# UNITED STATES PATENT AND TRADEMARK OFFICE

10/773,500

<b>Office Action Summary</b>	<b>Application No.</b>	<b>Applicant(s)</b>	
	10/773,500	CURRY ET AL.	
	<b>Examiner</b>	<b>Art Unit</b>	
	Benjamin P. Lee	3641

### **DETAILED ACTION**

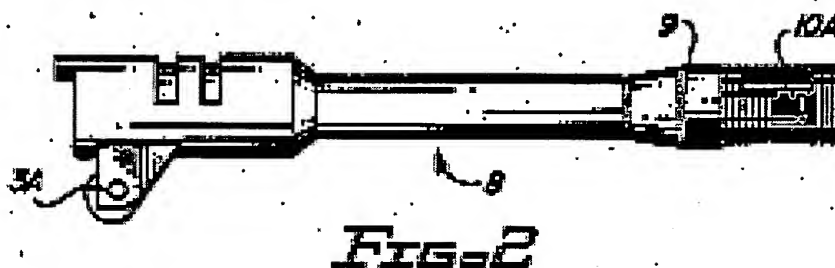
4. Claims 1 and 5 are rejected under 35 U.S.C. 102(b) as being anticipated by Kleinguenther et al. (U.S. Patent 5305677).
5. In regards to claim 1, Kleinguenther et al disclose the following:
  - a. a barrel having a longitudinal bore and defining thereby a firing axis (item 1 of fig. 2 following);
  - b. a compensator assembly including an attaching means for releasably

- c. a gas discharge port formed only in an upper three quarters of said compensator assembly (items 9 of fig. 2 following). Note that Kleinguenther et al does disclose a compensator assembly with a discharge port this is "formed only in an upper three quarters of the compensator". Applicant is advised that this language merely claims that a port must be formed only in the upper three quarters and not have any portion of "the port" in another part of the compensator;
- d. gas discharge port not being aligned with said longitudinal bore and communicating with an inner bore of said compensator assembly (see fig. 2 following). Note that the compensator walls define an inner bore and the exhaust ports are "communicating" with this inner bore.

2. In regards to claim 5, Kleinguenther et al disclose that the barrel includes a recess formed therein and said attachment means is configured to be releasably accepted within said recess (item 10 of fig. 2 following and col. 3, lines 18-20). Note that the threaded section constitutes a "recess" and the compensator attachment means

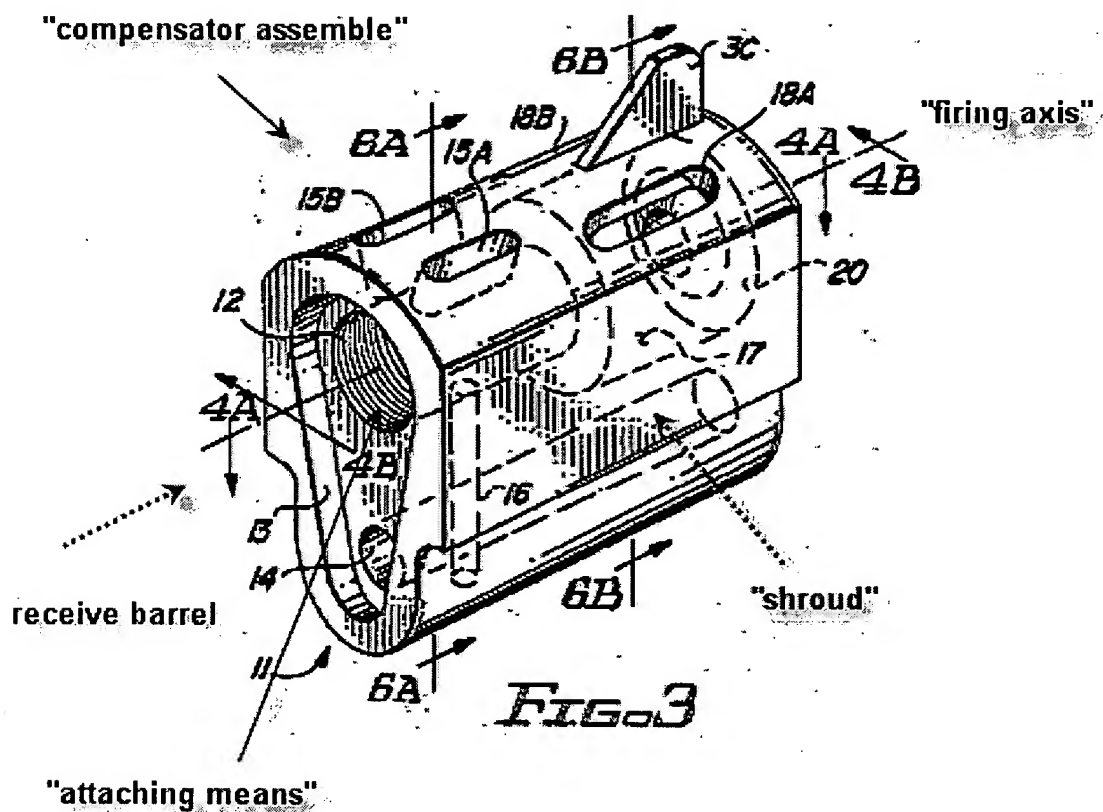
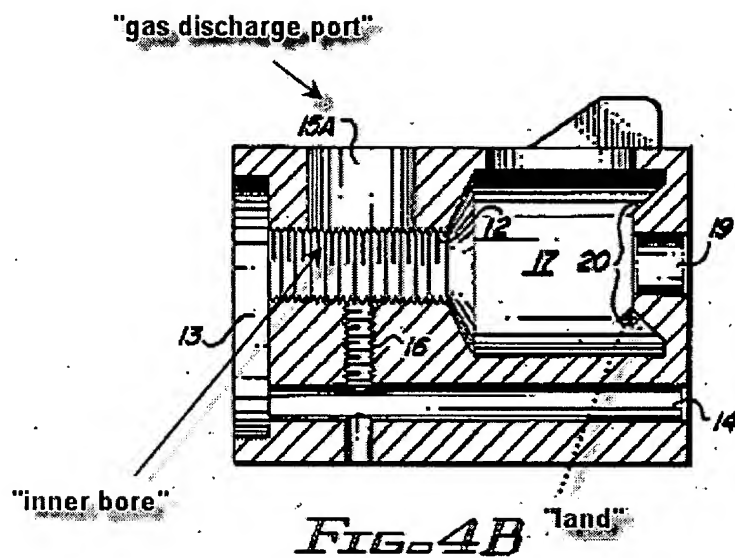
- a. a barrel having a longitudinal bore and defining thereby a firing axis (item 8 of Leffel et al fig. 2 following);
- b. a compensator assembly including an attaching means for releasably attaching said compensator assembly adjacent a muzzle end of said barrel (see Leffel et al figs. 2, 3 and 4B following);

- c. a gas discharge port (items 15A or 15B of Leffel et al fig. 3 following) formed in said compensator assembly, said gas discharge port not being aligned with said longitudinal bore and communicating with an inner bore of said compensator assembly (see Leffel et al fig. 4B following);

- d. said barrel includes a gas aperture (item 10A of Leffel et al fig. 2 following) which is aligned with said gas discharge port when said compensator assembly is attached adjacent said muzzle end of said barrel;

- e. said gas aperture not being aligned with said longitudinal bore (see Leffel et al figs. 2 and 3 following).

Leffel et al.

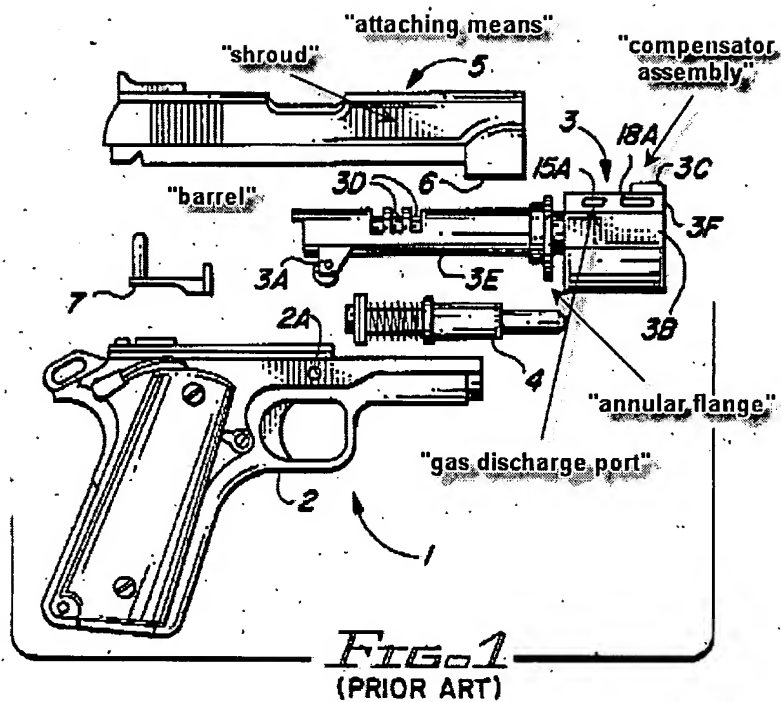
- a. a shroud having a longitudinal bore (item 5 of Leffel et al fig. 1 following);
- b. a barrel releasably housed within said shroud and defining thereby a firing axis (see Leffel et al fig. 1 following), said barrel including an annular flange disposed on a distal end of said barrel for arresting a longitudinal translation of said barrel within said longitudinal bore, said annular flange having a flange diameter which is greater than an outer diameter of said barrel (see Leffel et al fig. 1 following);

- c. a compensator assembly including an attaching means for releasably attaching said compensator assembly adjacent a muzzle end of said barrel (see Leffel et al fig. 1 following);

- d. a gas discharge port (item 15A of Leffel et al fig. 1 following) formed in said compensator assembly, said gas discharge port not being aligned with said longitudinal bore and communicating with an inner bore of said compensator assembly (see Leffel et al fig. 1 following).
